**From:** Arora, Surinder  
**Sent:** Wednesday, October 12, 2011 7:22 AM  
**To:** Miernicki, Michael; Ford, Tanya  
**Cc:** CCNPP3COL Resource; Colaccino, Joseph  
**Subject:** FW: Draft slides for November public Meeting  
**Attachments:** image001.png; Calvert\_Cliffs\_Site-Specific\_Seismic\_Analyses\_091511-OMT Comments Antonio.pptx

**NRC Public Meeting  
Calvert Cliffs Nuclear Power Plant Unit 3  
Discussion of COLA Site-Specific Seismic Analyses**

**September 14, 2011 Draft**

## Slide 11

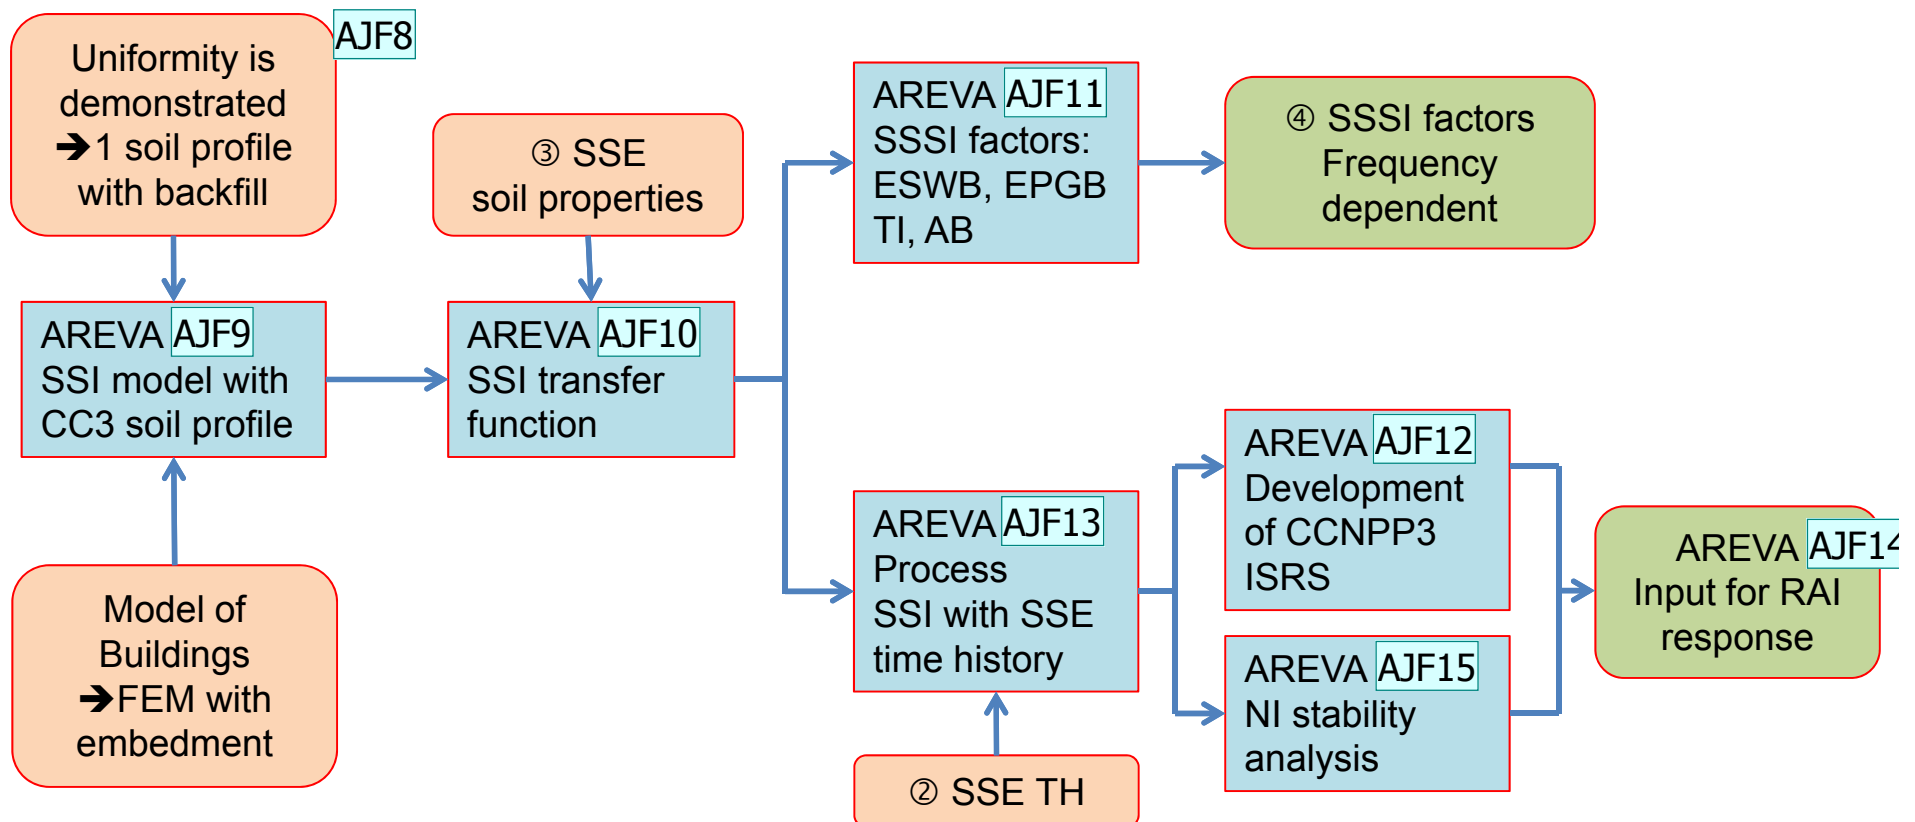
- AJF4** Delete contractor names  
Antonio J. Fernandez Ares, 9/22/2011
- AJF5** remove name  
Antonio J. Fernandez Ares, 9/22/2011
- AJF6** remove name  
Antonio J. Fernandez Ares, 9/22/2011
- AJF7** remove name  
Antonio J. Fernandez Ares, 9/22/2011

## Slide 12

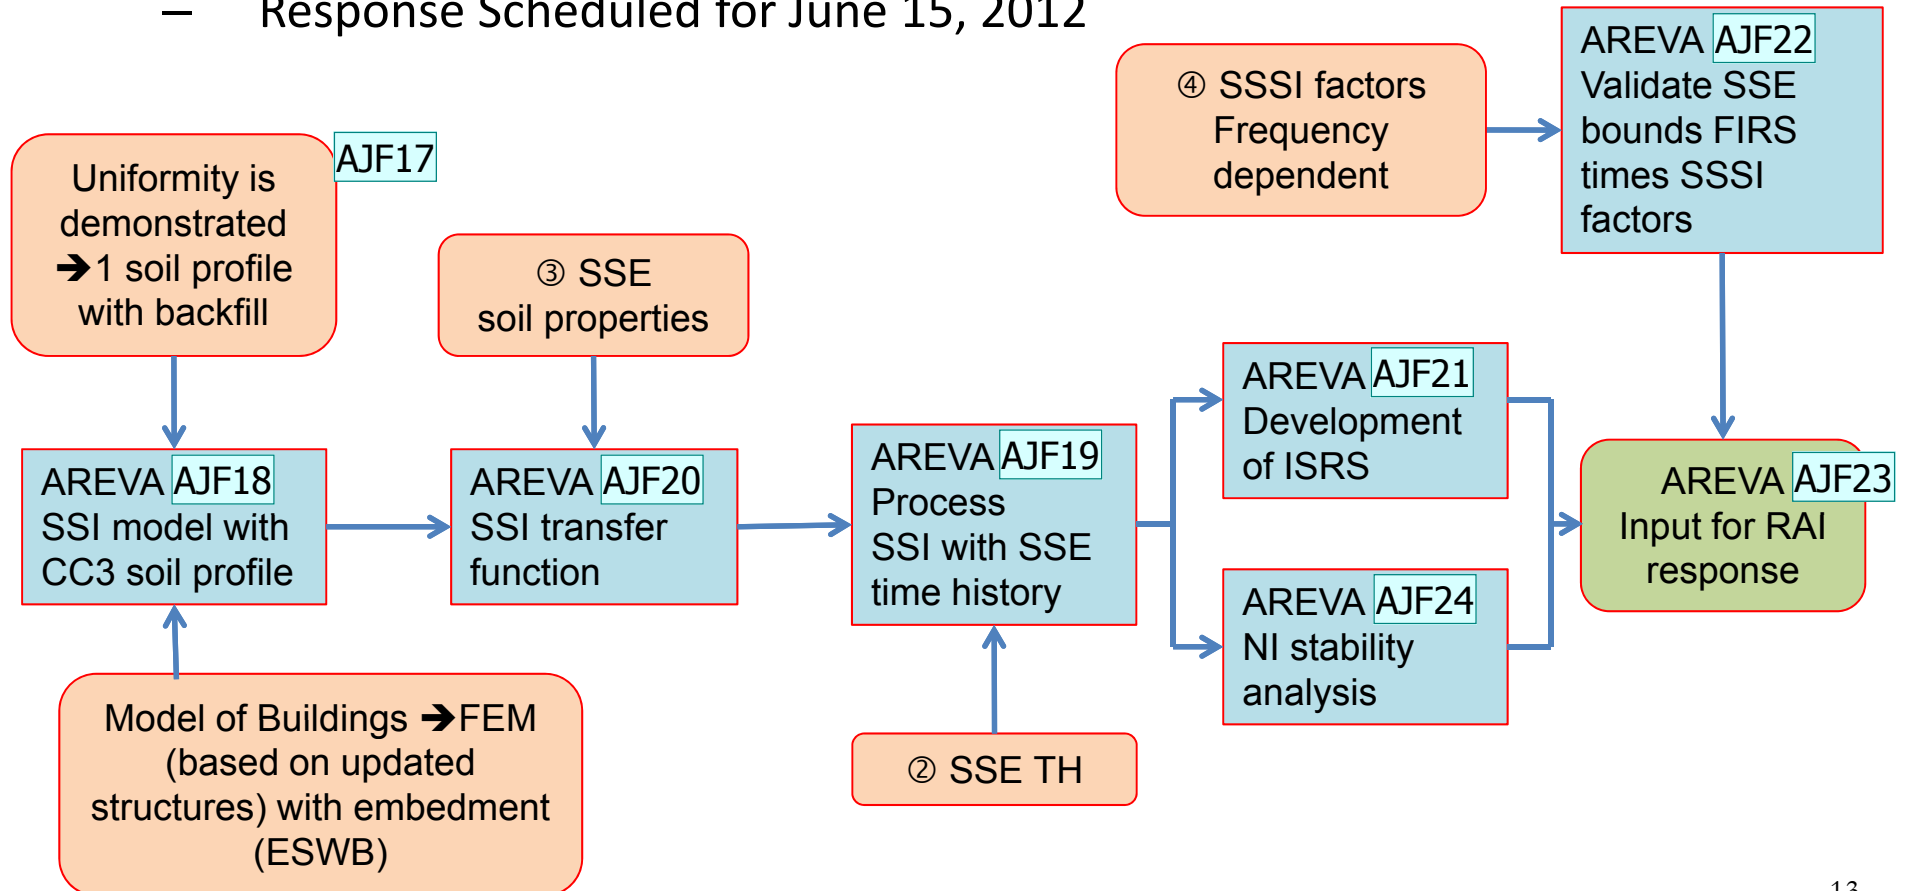
- AJF8** Remove this box and save discussion for later  
Antonio J. Fernandez Ares, 9/22/2011
- AJF9** Remove Name  
Antonio J. Fernandez Ares, 9/22/2011
- AJF10** Remove name  
Antonio J. Fernandez Ares, 9/22/2011
- AJF11** Remove name  
Antonio J. Fernandez Ares, 9/22/2011
- AJF12** Remove name  
Antonio J. Fernandez Ares, 9/22/2011
- AJF13** Remove name  
Antonio J. Fernandez Ares, 9/22/2011
- AJF14** Remove name  
Antonio J. Fernandez Ares, 9/22/2011
- AJF15** remove name  
Antonio J. Fernandez Ares, 9/22/2011

## Slide 13

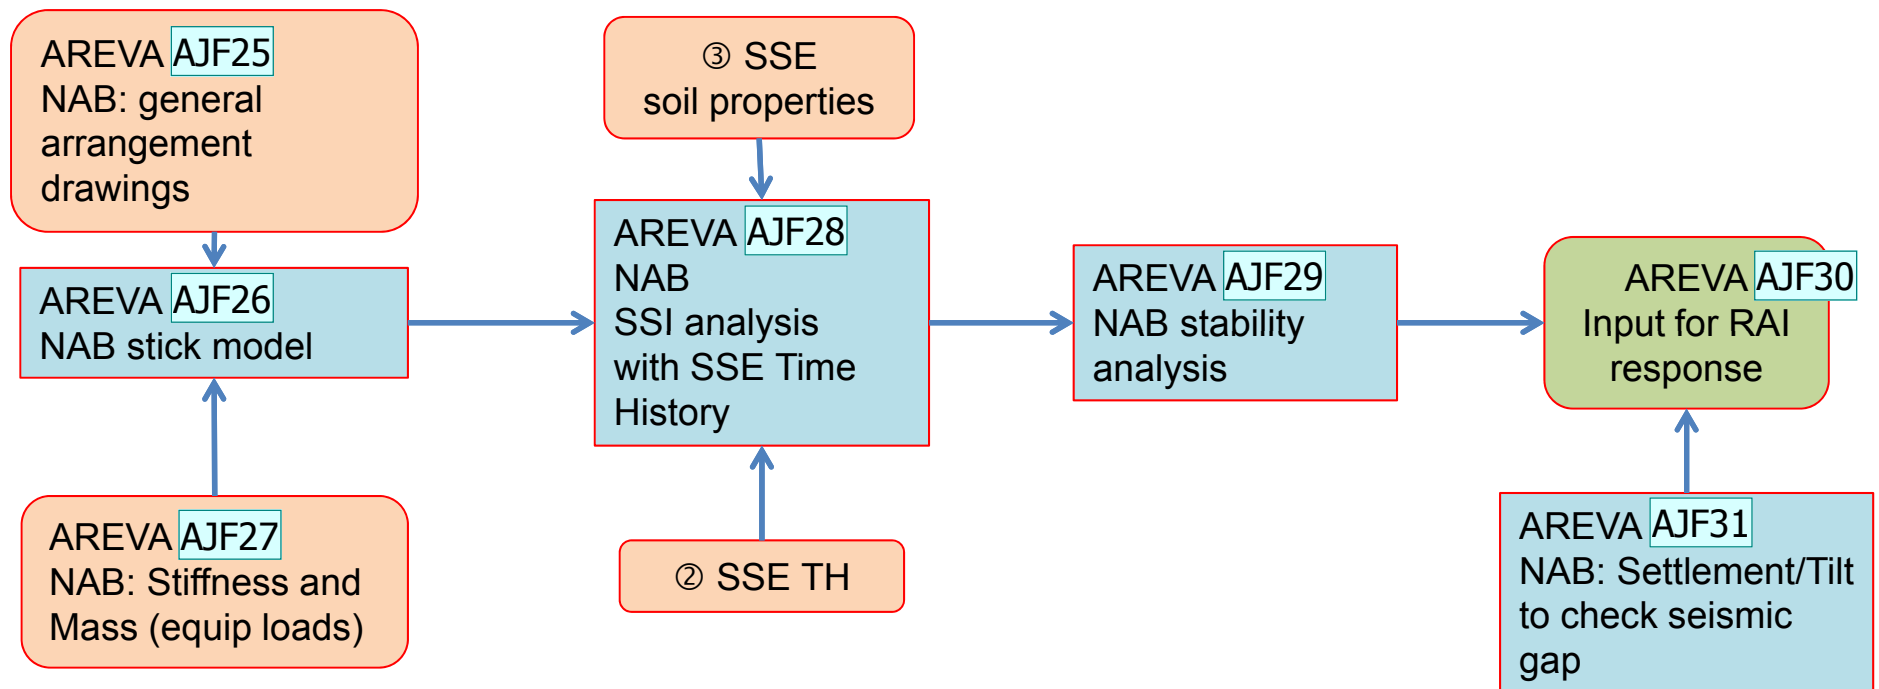
**AJF17** Remove Box and save discussion for later

**AJF18** Remove name

**AJF19** Remove name

**AJF20** Remove name

**AJF21** Remove name

**AJF22** Remove name

**AJF23** Remove name

**AJF24** Remove name

## Slide 15

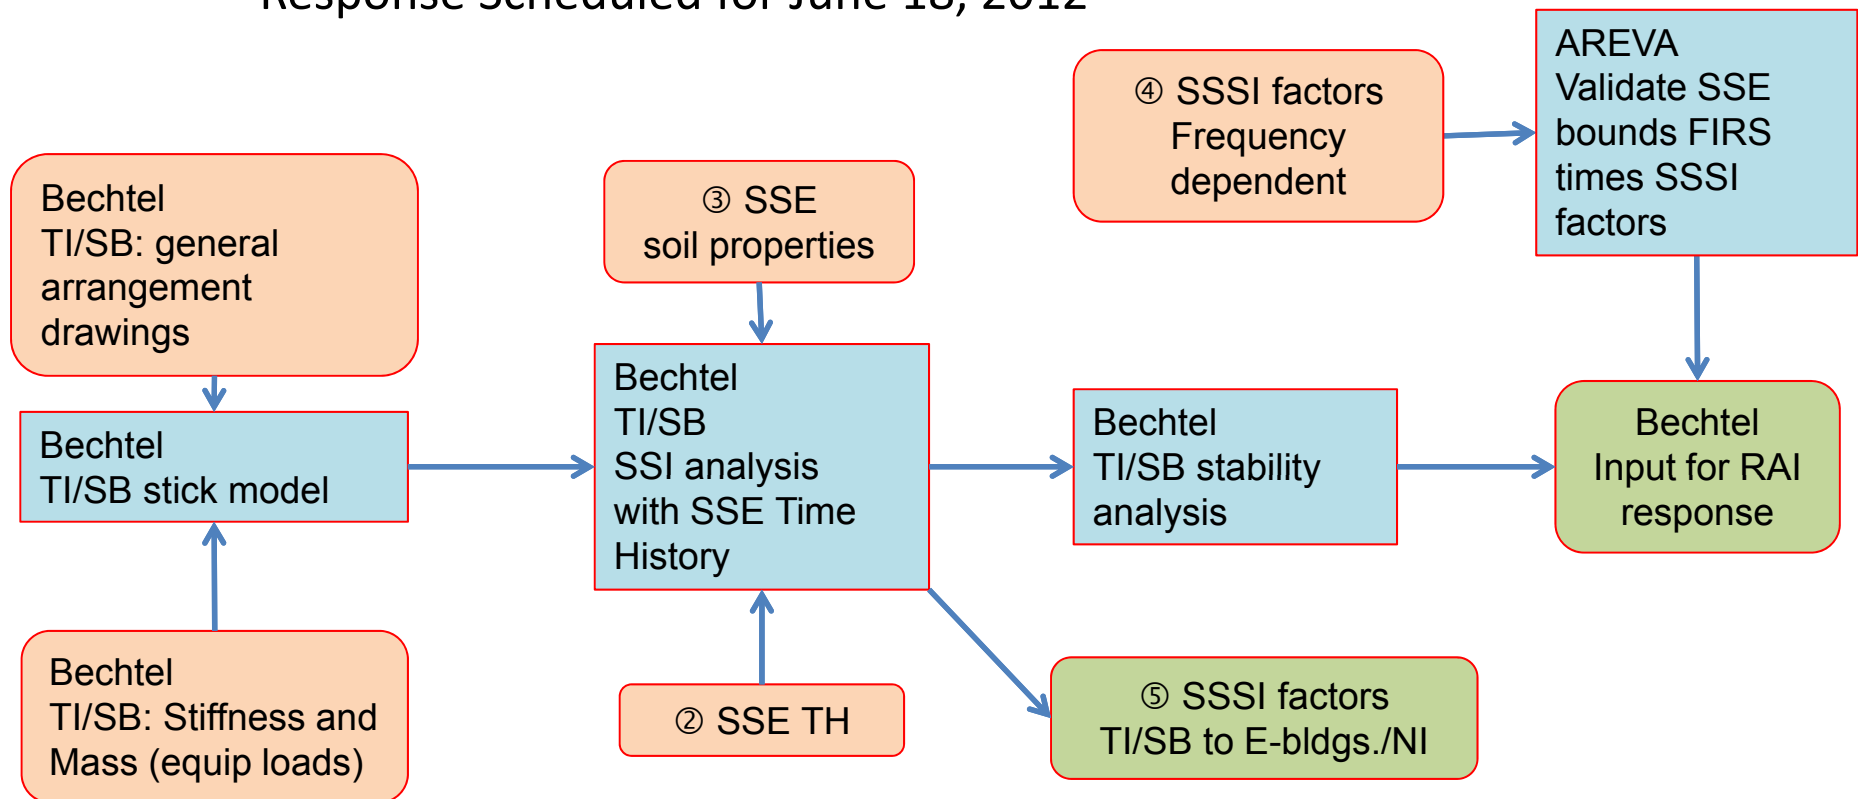
**AJF32**

**Remove names**

## Slide 16

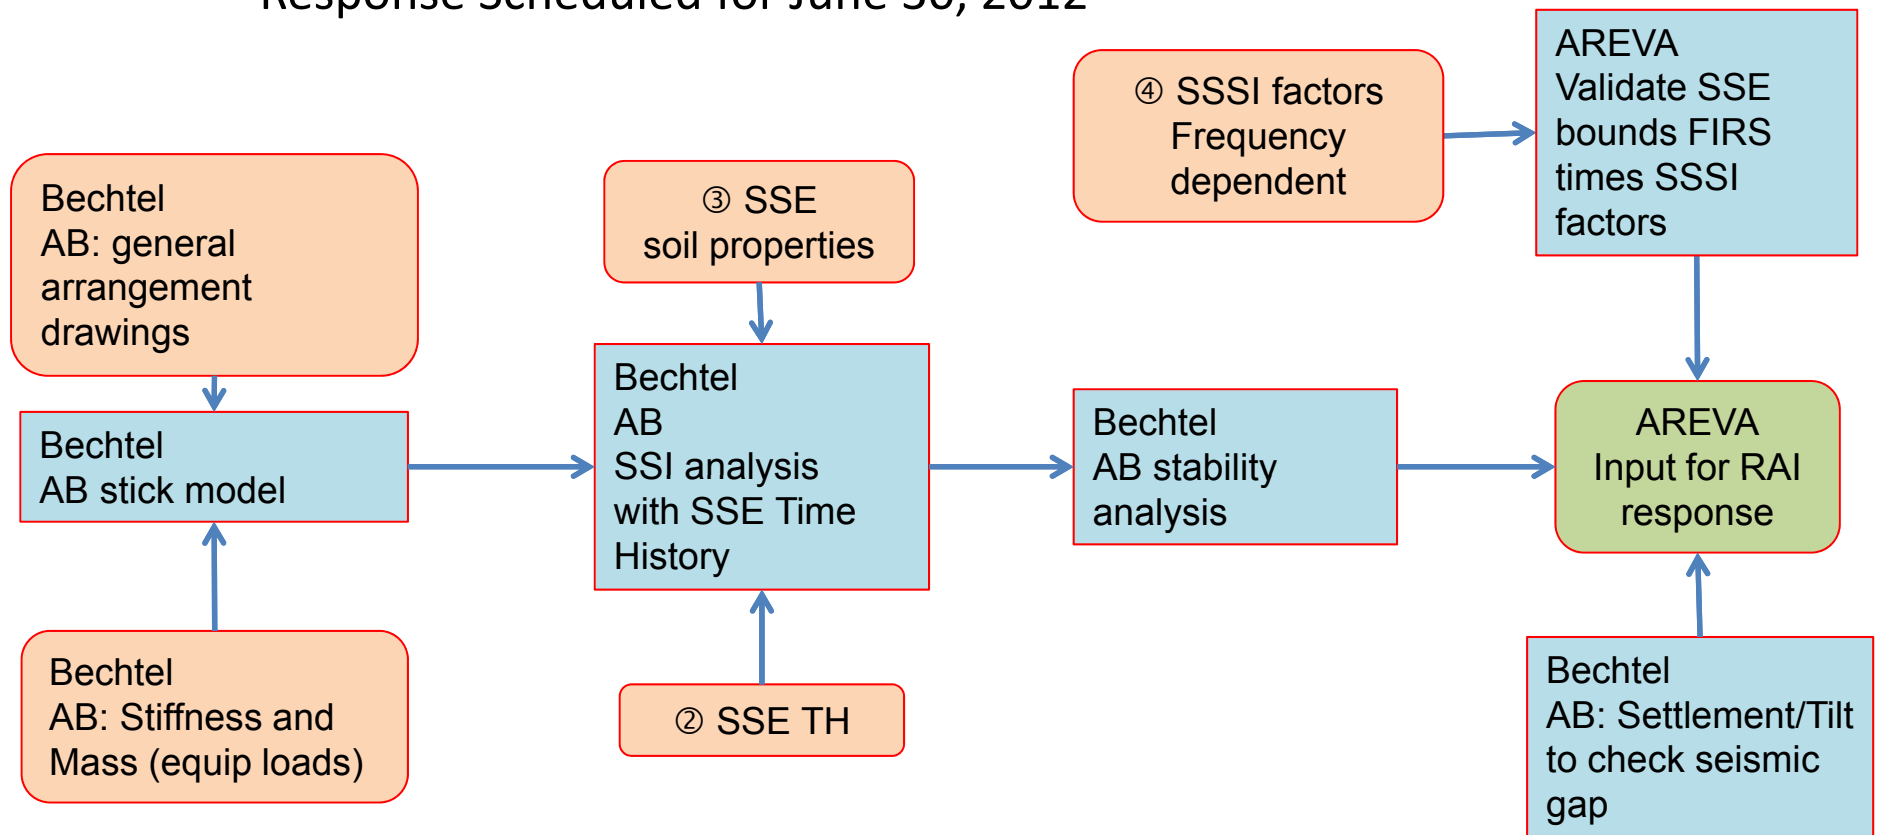
**AJF33**

**Remove names**

## Slide 19

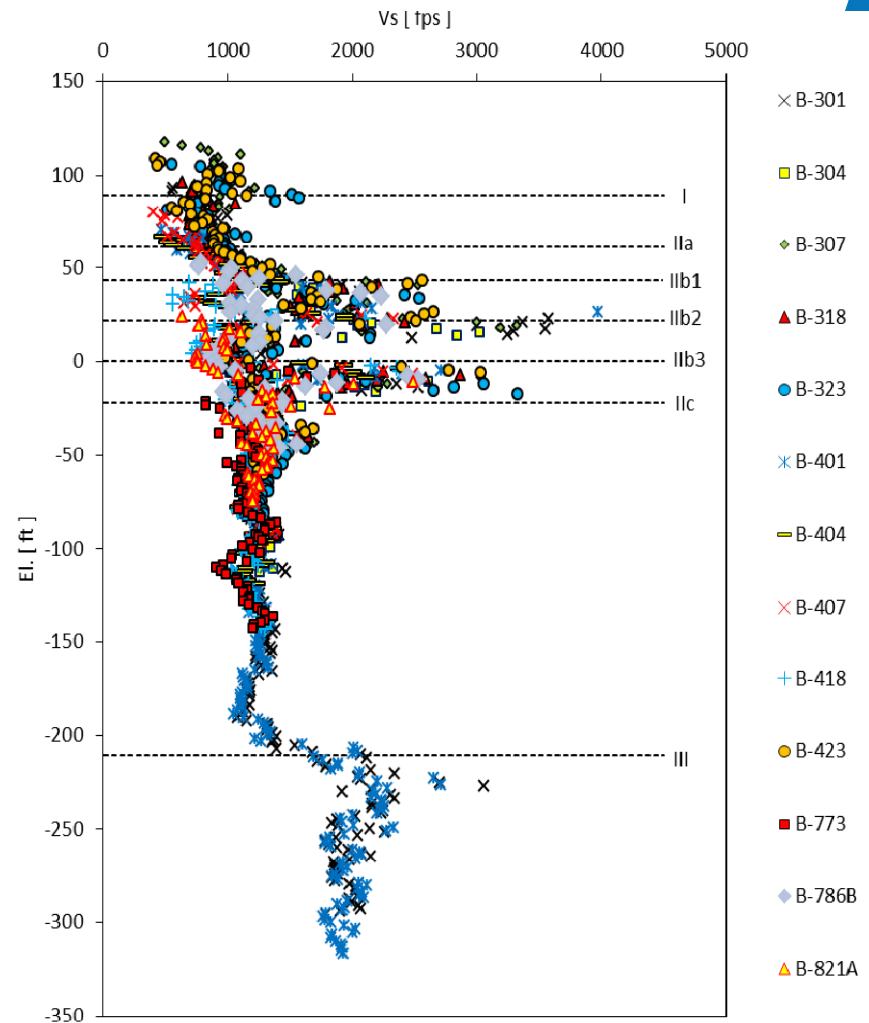
**AJF34**

Remove slide. This is water under the bridge

## Slide 24

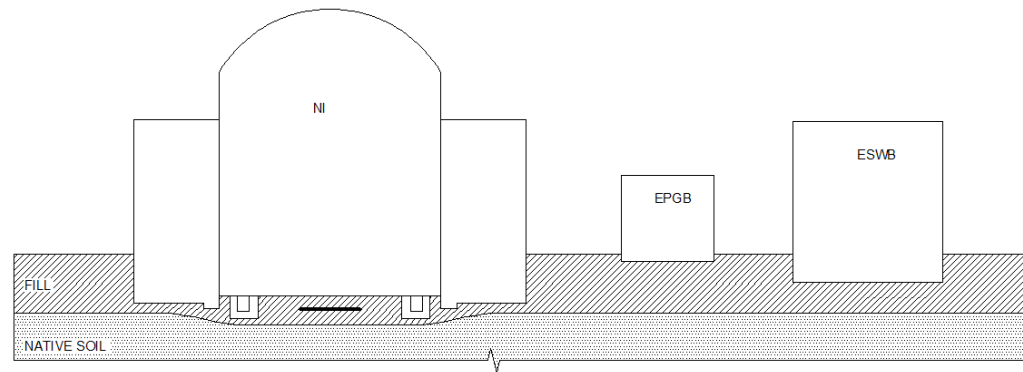
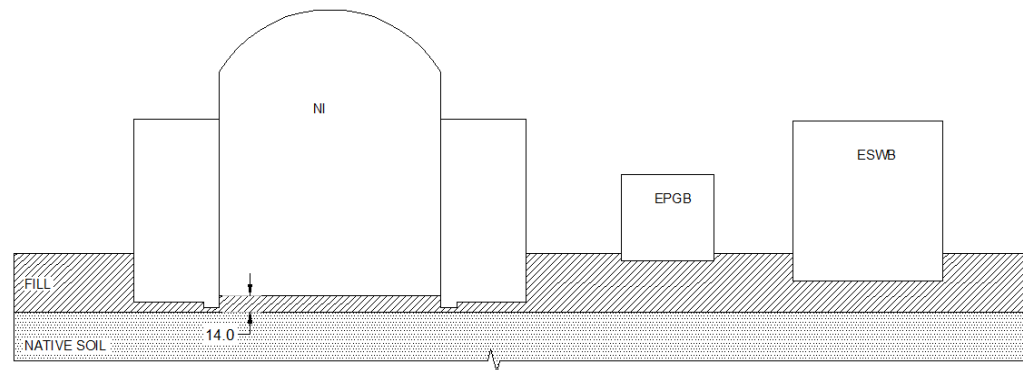
**AJF35**

and the DCD analysis

**AJF36**

We need to include a slide that shows how we are picking the Lower Bound from RB26 and the Upper Bound from RB36.
